Department of Mechanical and Nuclear Engineering
 College of Engineering
 The Pennsylvania State University
 137 Reber Building
 University Park, PA 16802-1412

DOCKET NUMBER
PROPOSED RULE 50
 (70FR 67598)

December 7, 2005

Figure 1

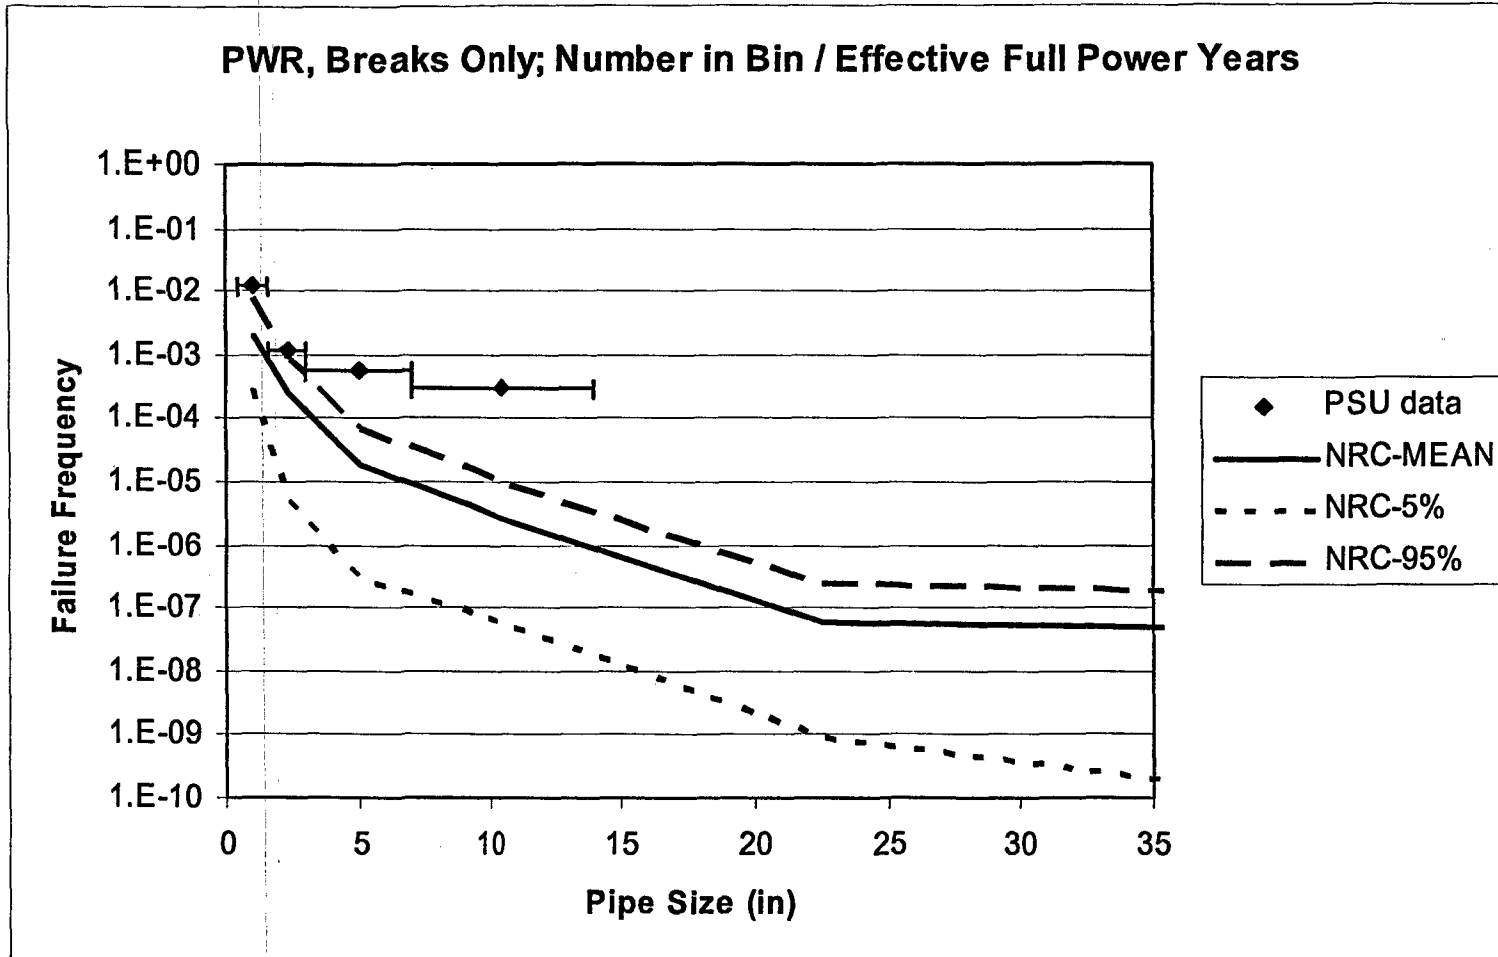
We have separated out "Breaks" from the total data base as a separate plots for both PWRs and BWRs as shown in Figures 1 and 2. As these figures indicate, there are no large breaks in the class 1 piping. However, for the smaller breaks, the data clearly lies above the estimated break frequencies estimated in the NRC solicitation study. The data is above the 95% percentile as compared to the NRC break frequency plots indicating that even smaller breaks are more frequent as compared to the estimated frequencies from the solicitation study.

Figure 3

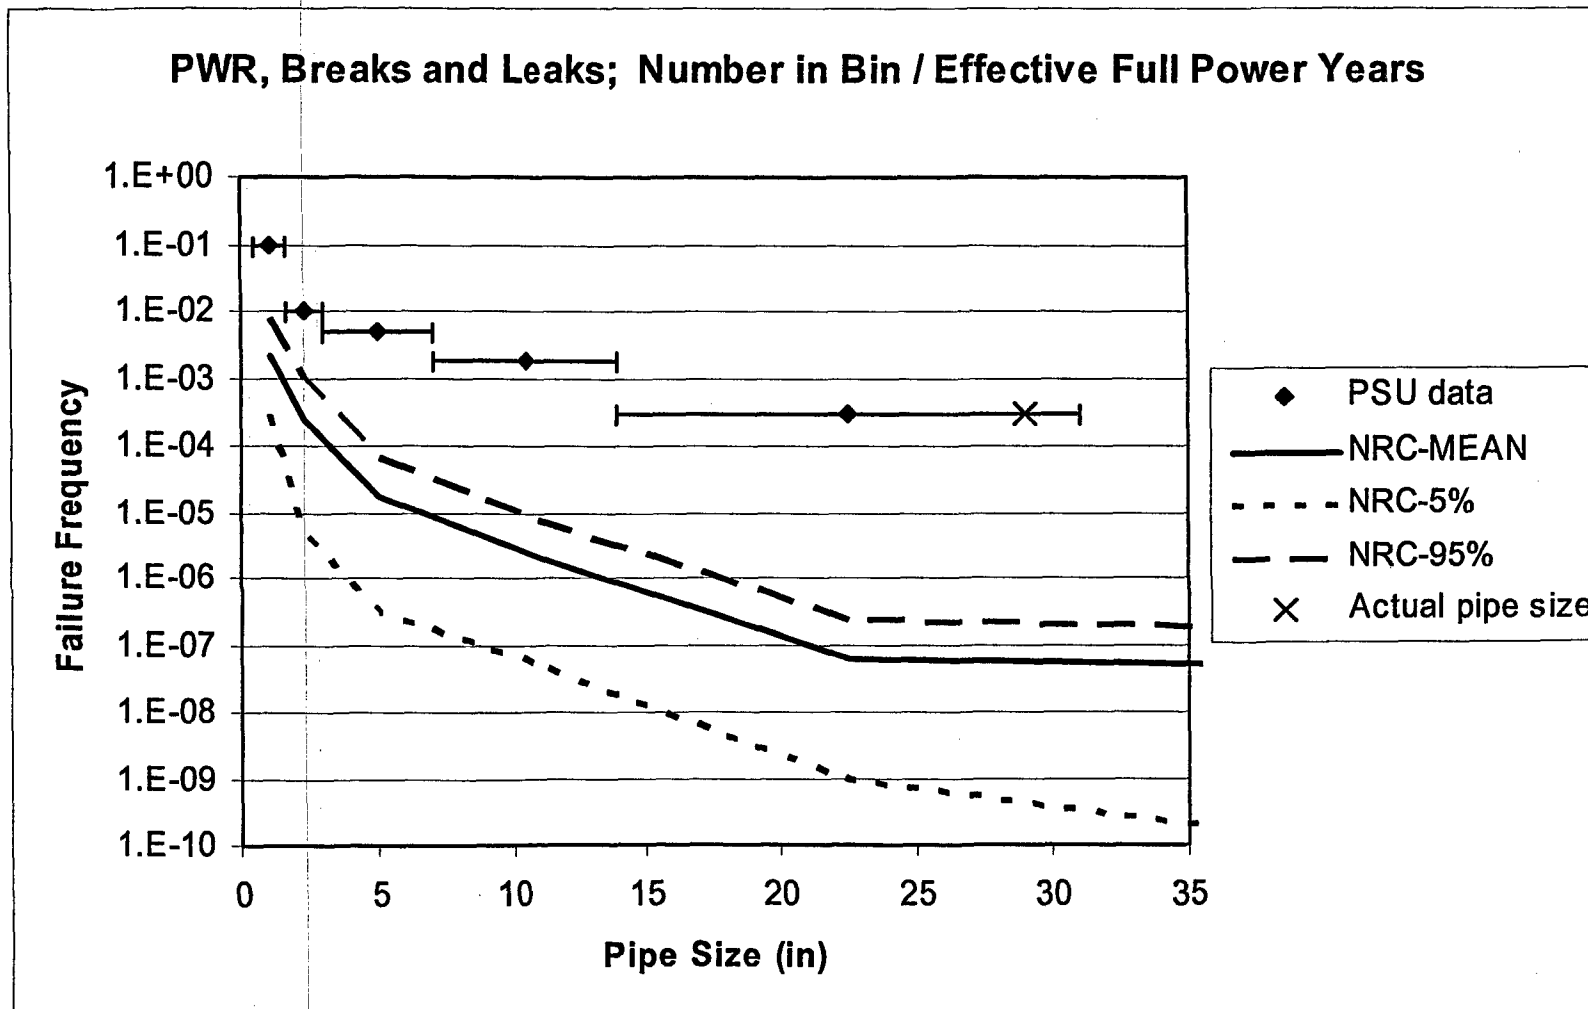
We also have combined "Breaks" and "Leaks" together on a separate plots for PWRs and BWRs as seen in Figures 3 and 4. The rationale for this is that leaks are really breaks since the pipe has failed and is leaking. We used the size of the pipe for when combining the leaks with the breaks. This may not be the best method of comparing the data to the break frequency distribution and it may appear to bias the results since there are only leaks for the larger pipes and not breaks. However, it is not clear that, given a set of conditions, a leak in a large pipe could grow to a full pipe size break. Say for example, under a safe shutdown earthquake condition. Also, this grouping could be viewed as being conservative since the original premise is that the pipes should not leak in the first place.

All the data, breaks and leaks, when combined in this form indicate that there is a significant difference between the existing data and the break spectrum failure frequencies from the NRC expert solicitation study. This indicates to me that we should not be revising 10CFR50.46 by introducing a "transitional break size" and reducing the mitigation capabilities of the plant's ECC systems and defense in depth for the larger break sizes. I believe that we need to maintain the full functional capability of the robust ECC systems that we have in the current operating plants for all possible break sizes up to and including the full double-ended break of the reactor coolant piping. The break and leak data for the class 1 piping indicates to me that we need the full functional ECC systems and their supporting systems and they should not be compromised or sacrificed by revising 10CFR50.46.
